**CITY OF ST. HELENS PLANNING DEPARTMENT
STAFF REPORT
Conditional Use Permit CUP.1.26**

LOCATION: 184 S. 15th Street

PROPOSAL: Complete building addition started c. 2014 but never completed, establish use as an artisan workshop or trade/skilled services with outdoor storage, and address unapproved site modifications.

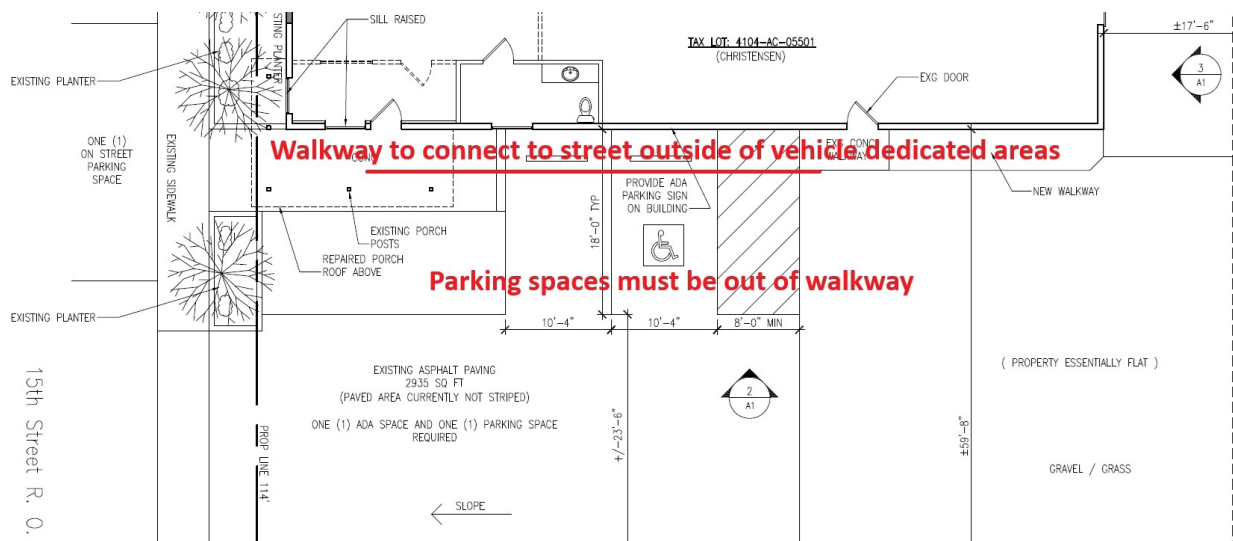
Off-Street Parking/Loading: Off street parking is required. There is a paved parking area, though it is underdeveloped lacking parking space markings.

Dimensions. Standard parking spaces are 9' x 18'. For two-way vehicle circulation, 24' width is required. Thus, in order to have a row of standard parking spaces on either side of a 24' two-way aisle, the minimum width dedicated to vehicle use needed is 18+24+18 or 60 feet.

The site plan identifies 59'8". However, upon measurement by staff towards the middle of the paved parking lot area there is about 58 feet between the building and the fence along the south property line.

1 SITE PLAN
 SP-1 1/8" = 1'-0"

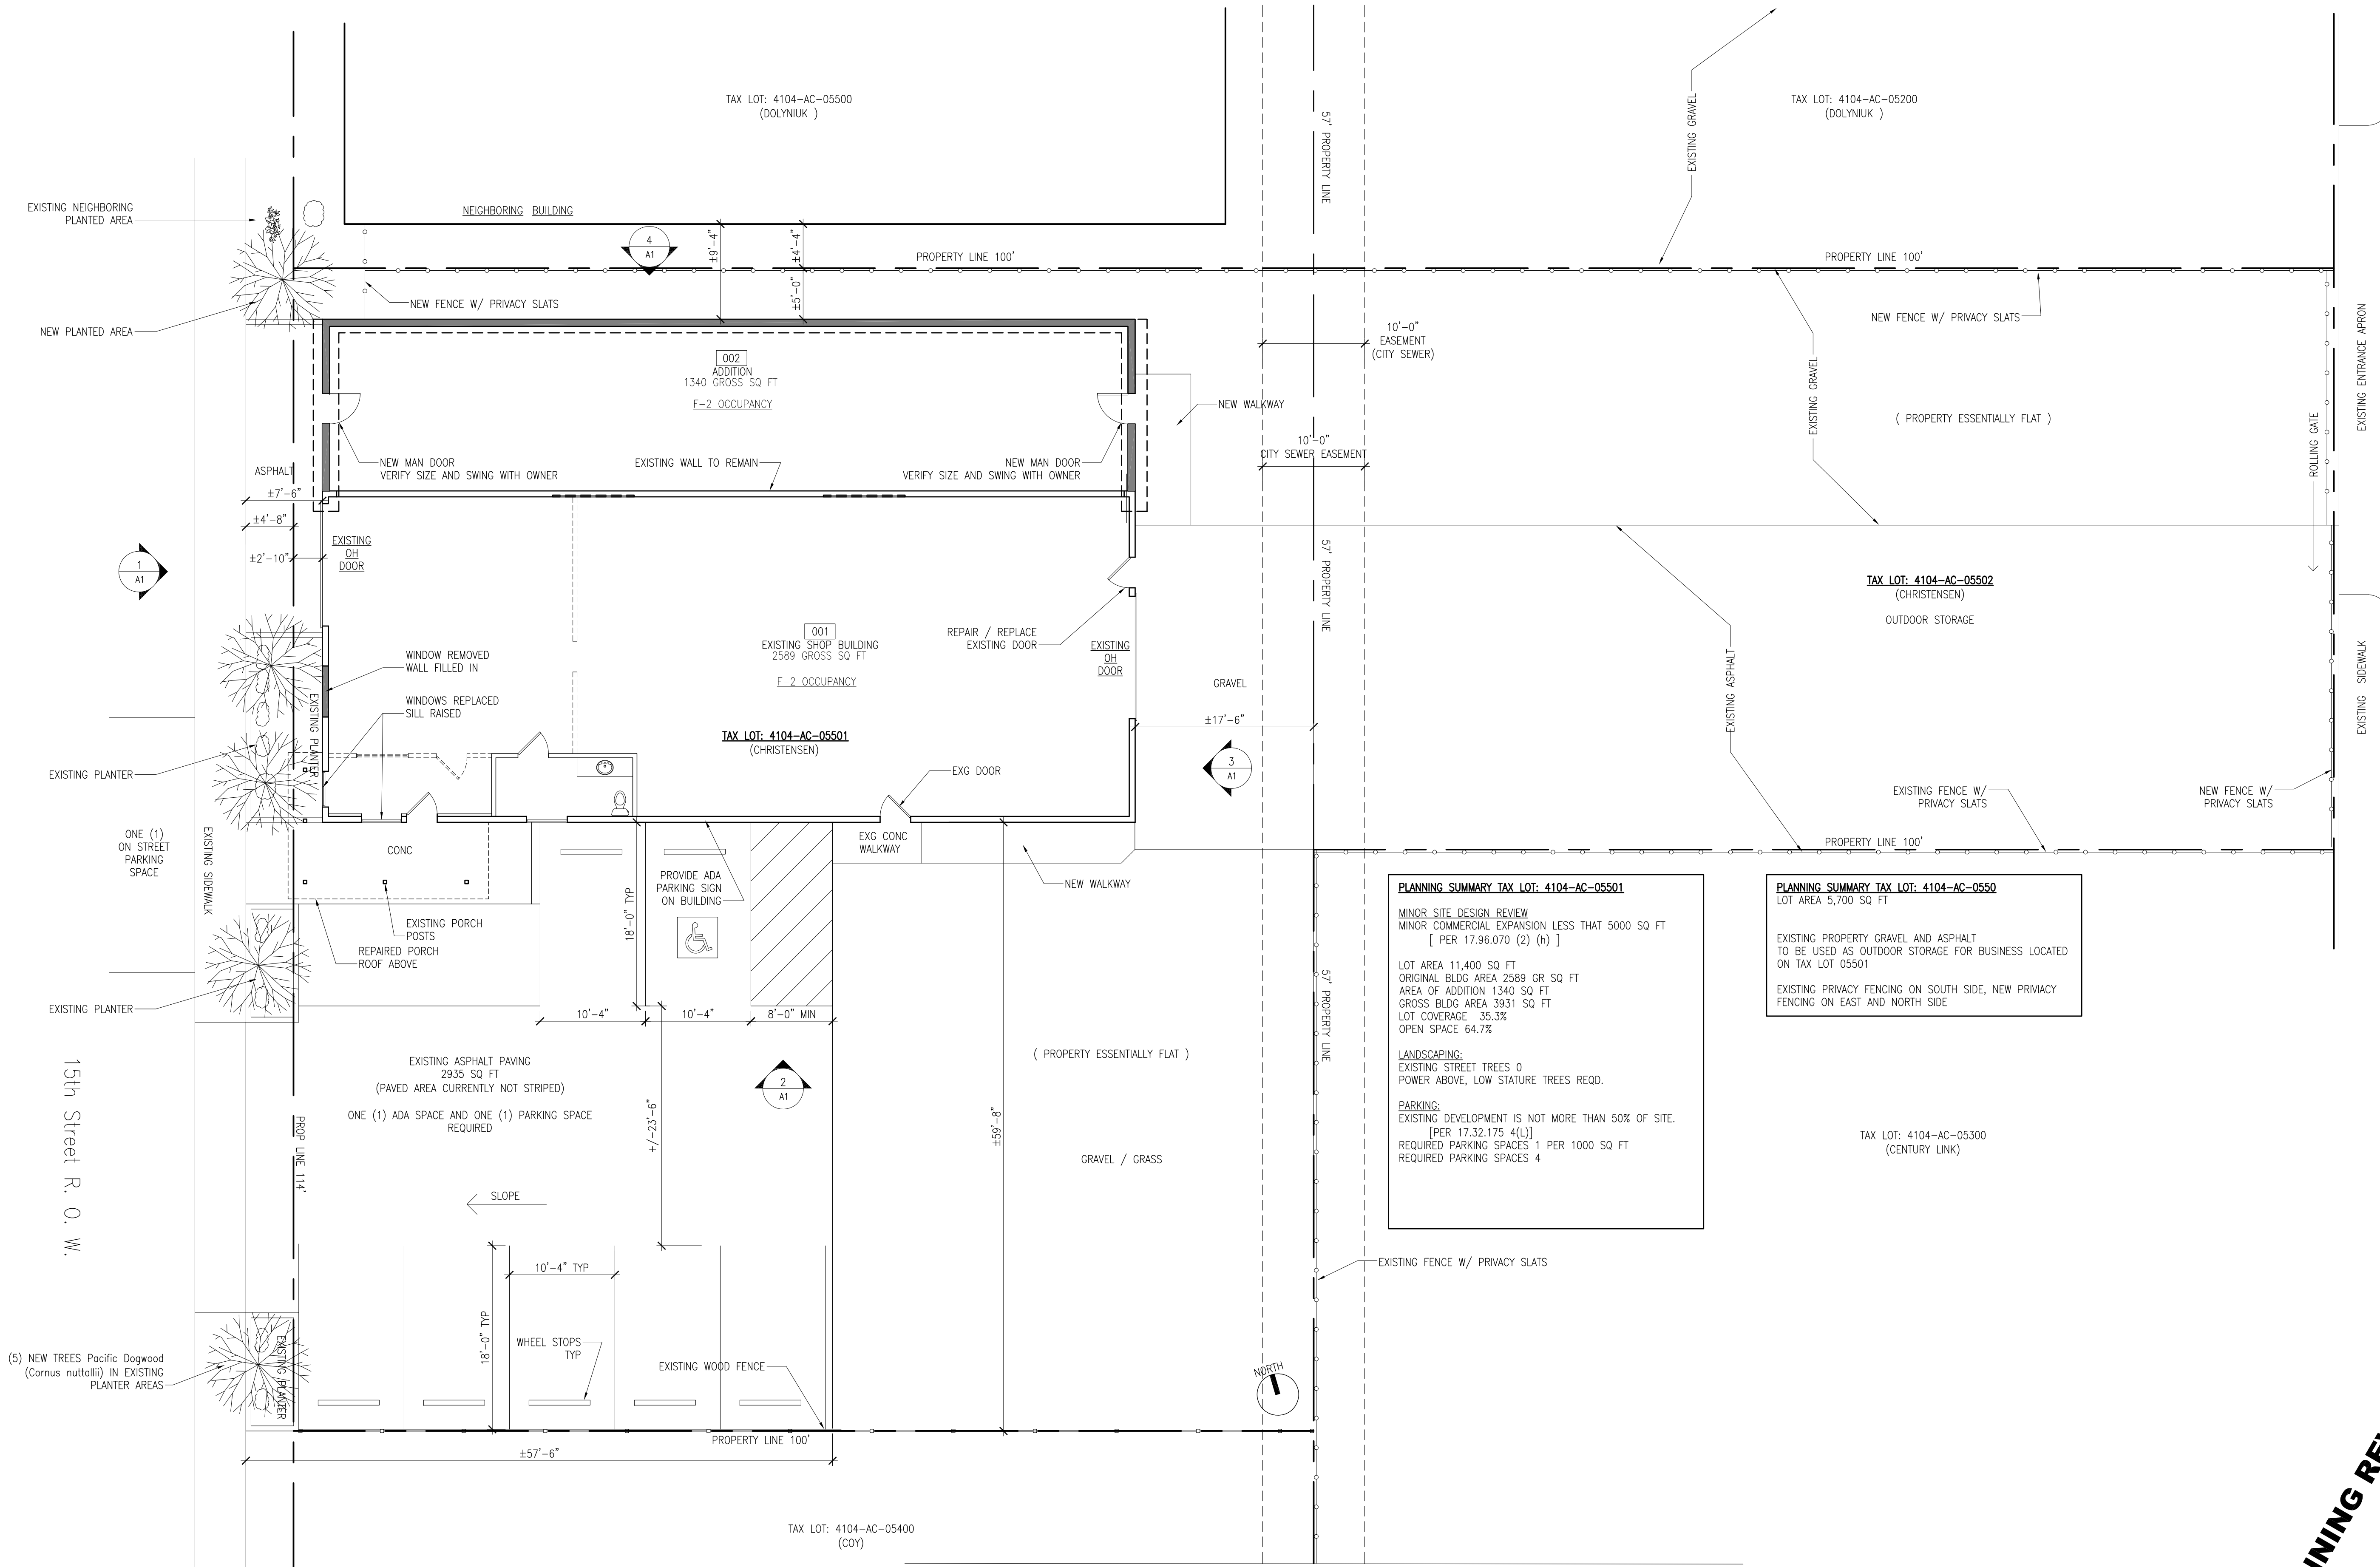
This raises accuracy concerns of the plans. As another example, measured on the plans, there is about 201' between the back edges of the sidewalks along S. 14th and S. 15th Streets. Measuring from aerial photos there is actually about 208'. It is also possible that the fence along the south property line is within the subject property, which may result in the claimed 59'8" dimension on the site plan (if measured to the property line), though, given the location of the fence, that is not the physically available area.

Moreover, a swath of area adjacent to the south side of the building has to be included as walkway that is either 4' wide or 7' wide (see access section below), which reduced this width further.

Plans revisions are needed for accuracy, better quality control and code compliance.

As noted above, plans show some walkway but not a connection to the street that avoid areas intended for vehicle use. Revised plans necessary. Minimum walkway width area is 4 feet and are required to be paved.

2. The following shall be required prior to commencement of any use:
 - a. Final plans shall include the following revisions:
 - i. Open space areas shall be specially identified and quantified. Open space cannot be areas used for other things such as storage, access, parking, etc.

- ii. All walkways, vehicle ways, and off-street parking shall be paved.
 - iii. Landscaping to achieve a balance of low-lying shrubbery and trees in addition to the proposed trees for the landscape areas along S. 15th Street. Methods of irrigation / plant maintenance for plant survival shall be identified.

- iv. Refuse container/collection area shall be addressed.
 - v. Plans shall be properly calibrated to existing (e.g., CS 5174 from 2004) or new surveys.

- vi. Parking lot design shall be updated based on actual physical space available, previous or new survey information, not obscuring a walkway path abutting the south side of the building, and ensuring maneuvering and turn-around area within the property, so maneuvering and backing movements will not occur within S. 15th Street.
